DESIGN <i>CP</i>	DRAWN BY <i>CP</i>	DART AEROSPACE LTD HAWKESBURY, ONTARIO, CANADA	
CHECKED <i>#</i>	APPROVED <i>#</i>	DRAWING NO. D3016	REV. A SHEET 1 OF 3
DATE 01.05.18		TITLE SEAT FRAME ASSEMBLY	SCALE NTS
A	01.05.18	NEW ISSUE

DRAWING NO. D3016	TITLE SEAT FRAME ASSEMBLY	REV. A	DART AEROSPACE LTD ENGINEERING ORDER	D.E.O. NO. D3016-A-1	SHEET NO. SHEET 1 OF 1	SCALE NTS
DRAWN <i>1</i>	CHECKED <i>UP</i>	MFG. APPR. <i>RE</i>	APPROVED <i>MP</i>	DE APPR. <i>#</i>		
DATE 10.01.29	DATE 10.01.29	DATE 10.01.29	DATE 10.01.29	DATE 10.01.29

TO REVISE D3016-11 SADDLE'S HOLE SIZES

D3016-11 SADDLE

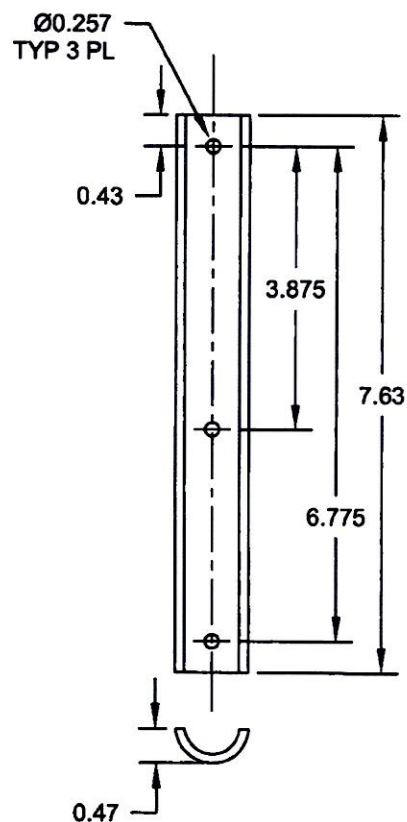
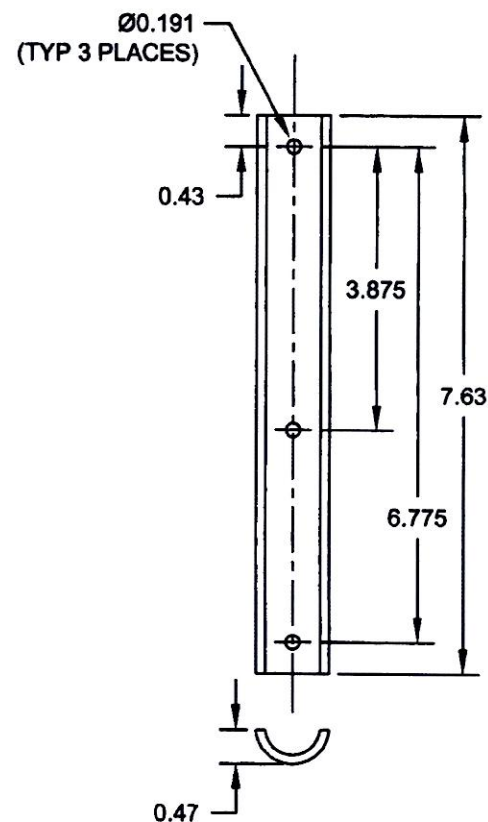
DETAIL D3016-11 SADDLE (SHEET 3): Ø0.257 TYP 3 PL WAS Ø0.191 (TYP 3 PLACES) AS SHOWN:
